STERLING RANCH EAST FILING NO. 5

CONSTRUCTION DRAWINGS

OCTOBER 2024

DESIGNED BY	PRA	SCALE	DATE	10-31-24
DRAWN BY	PRA	(H) 1" = 50'	SHEET	5 OF 31
CHECKED BY	(V) 1" = N/A	JOB NO.	1183.25

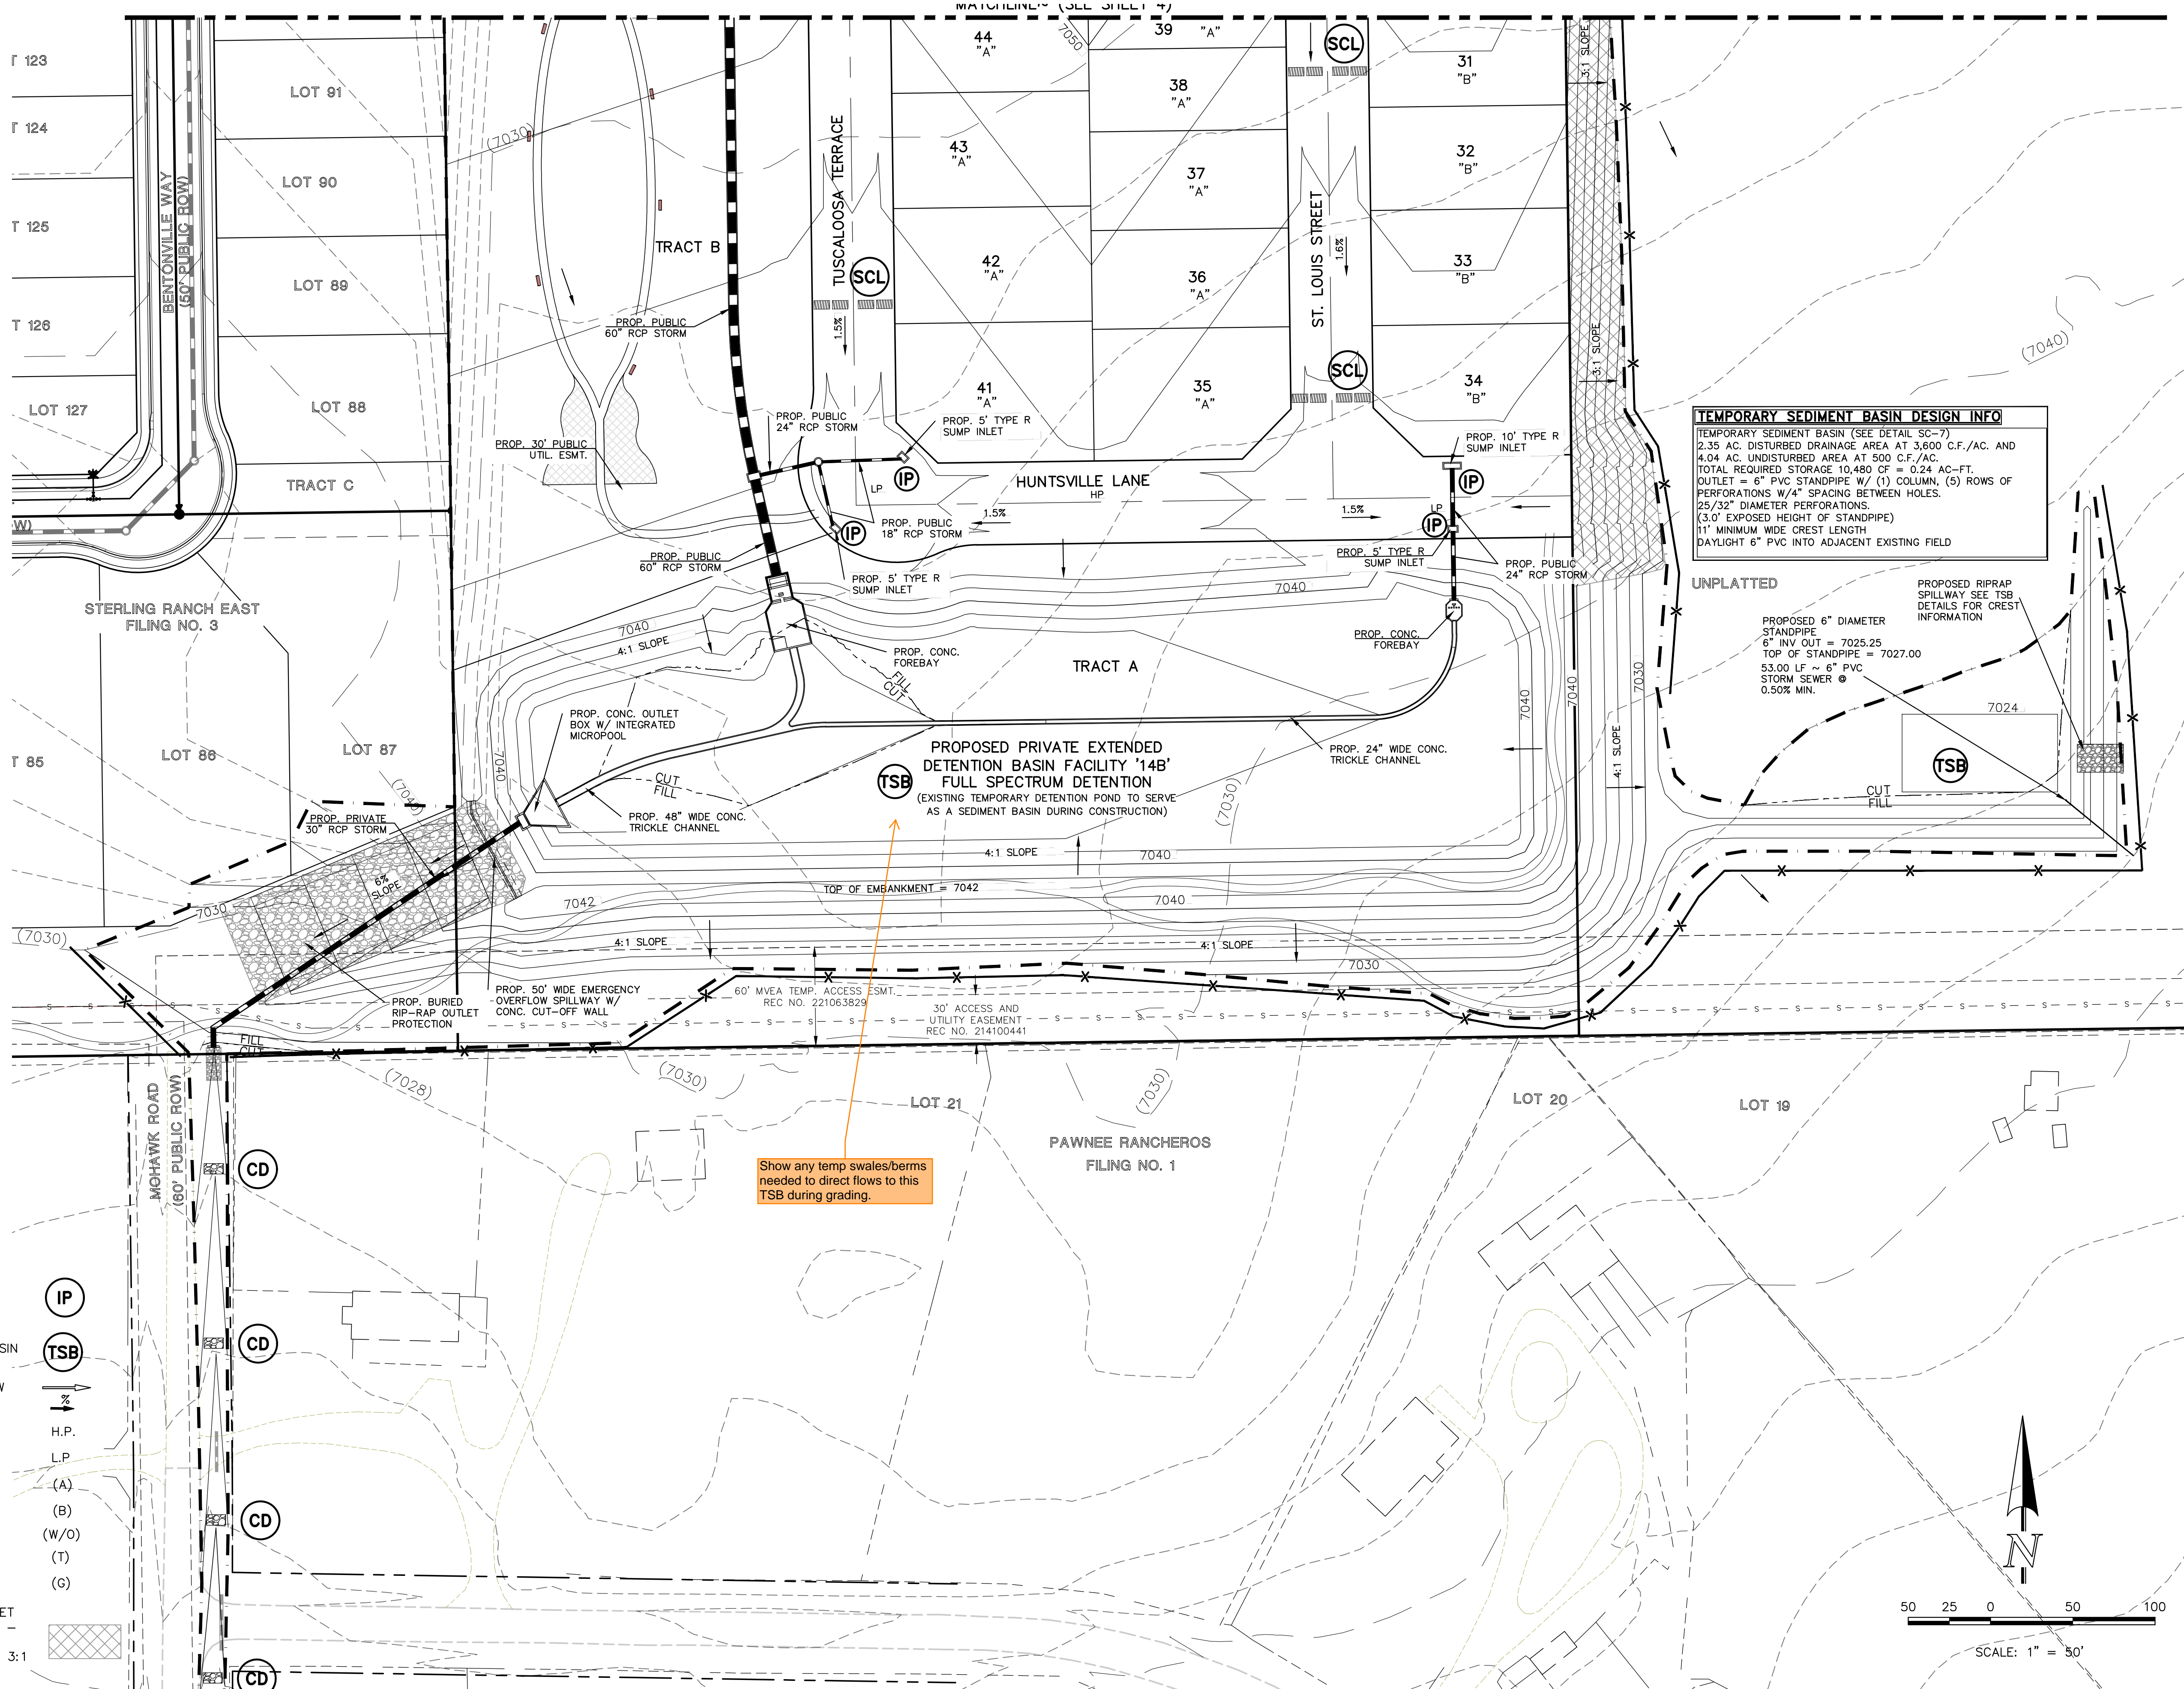
Show any temp swales/berms needed to direct flows to this TSB during grading.

TSB
 STORMWATER ENTERPRISE
 TEMPORARY SEDIMENT BASIN
 10/7/19 6/18/2020 900-TB-2

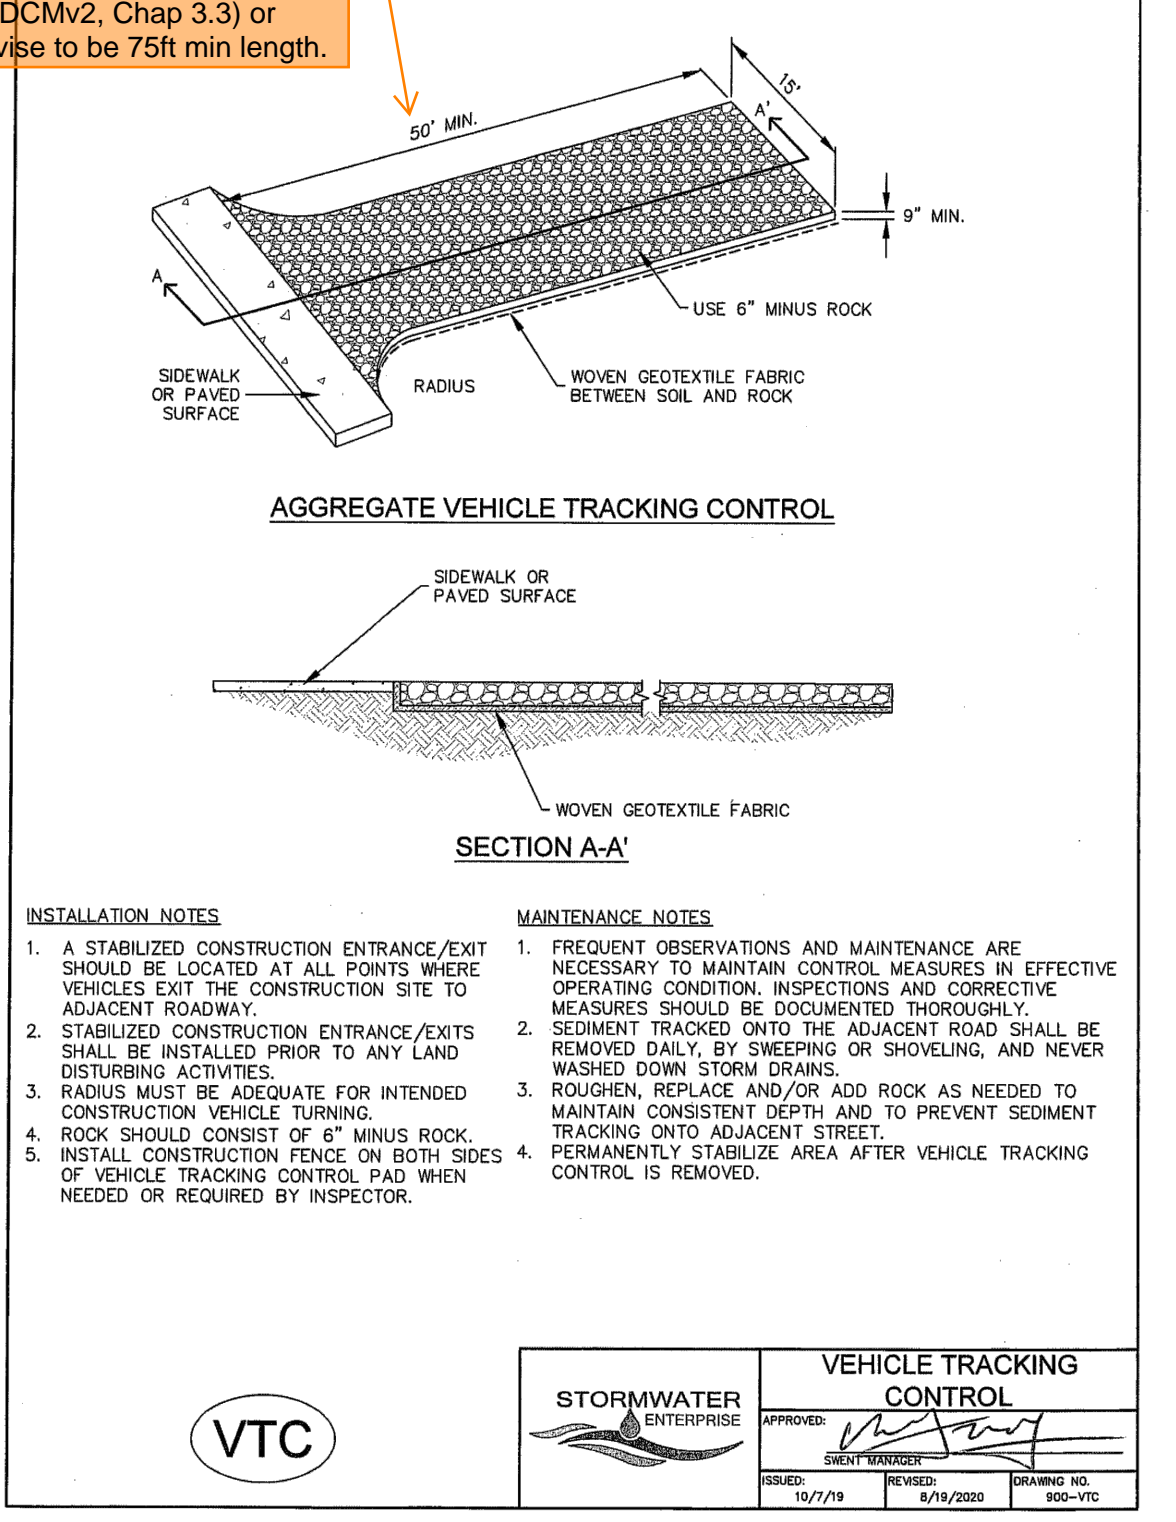
Replace with EPC approved VTC detail (VT-1 and VT-2 in DCMV2, Chap 3.3) or revise to be 75ft min length.

LAKE TAHOE DRIVE
(50' R.O.W. - URBAN LOCAL)
DESIGN SPEED 25 MPH

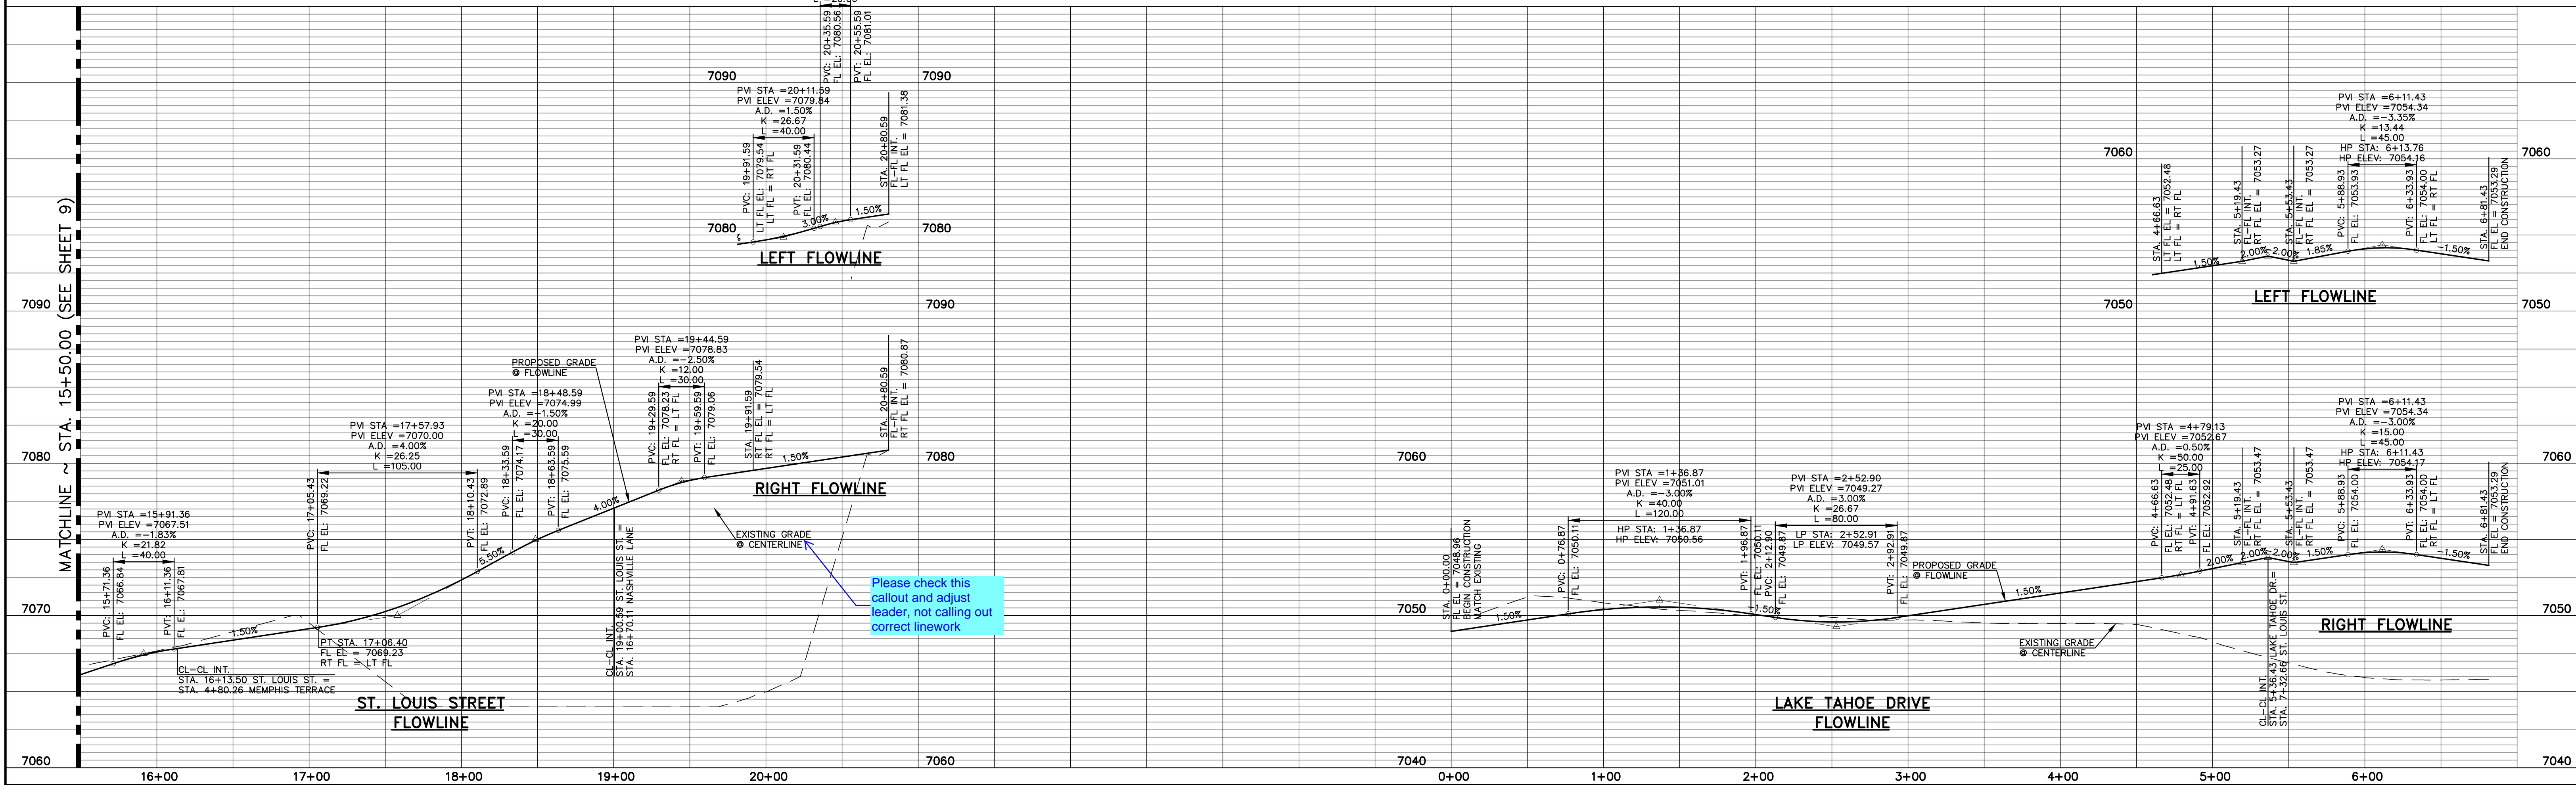
Please check this callout and adjust leader, not calling out correct linework

NO.	REVISION	DATE																													
DESIGNED BY	PRA	SCALE	DATE	10-31-24																											
DRAWN BY	PRA	(H) 1" = 50'	SHEET	23 OF 31																											
CHECKED BY	(V) 1" = 5'	JOB NO.	1183.25

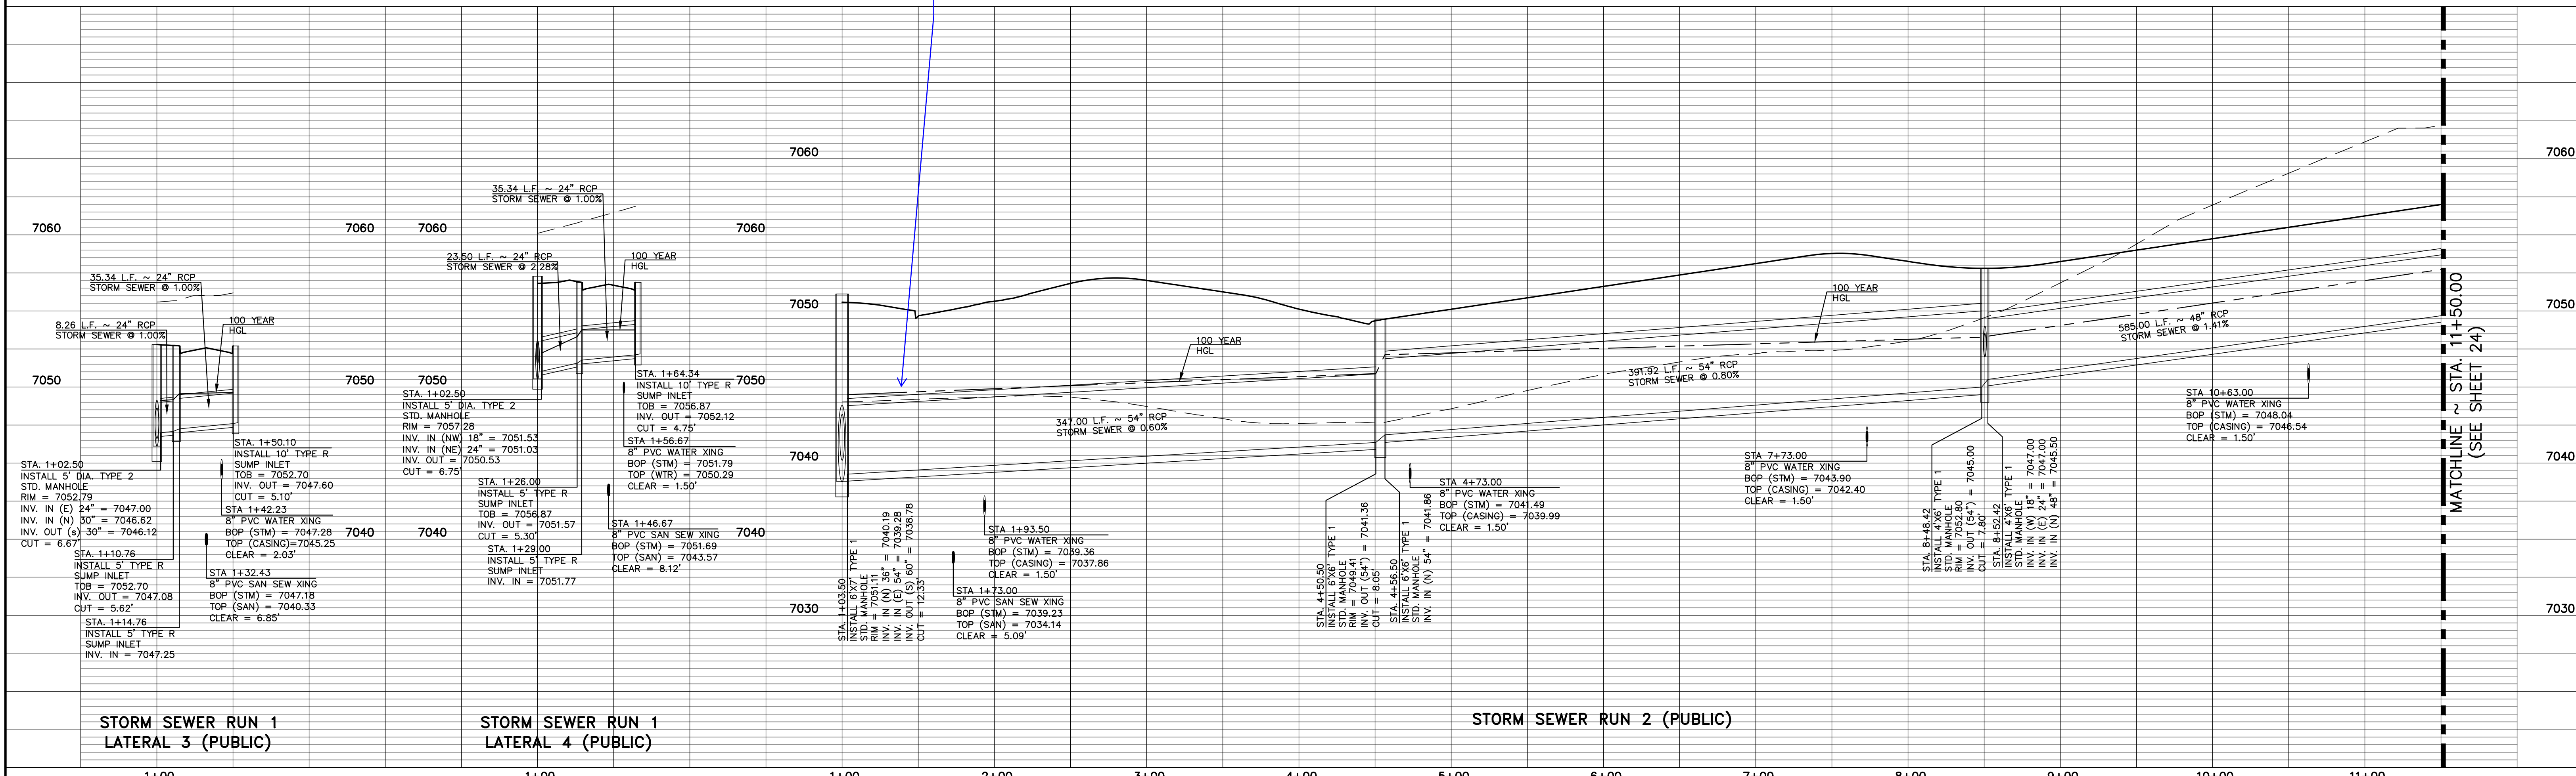
Please include a note for All storm sewer with 100-YR HGL above the top of the pipe shall be installed with pressure pipe and watertight joints with 100 year service life
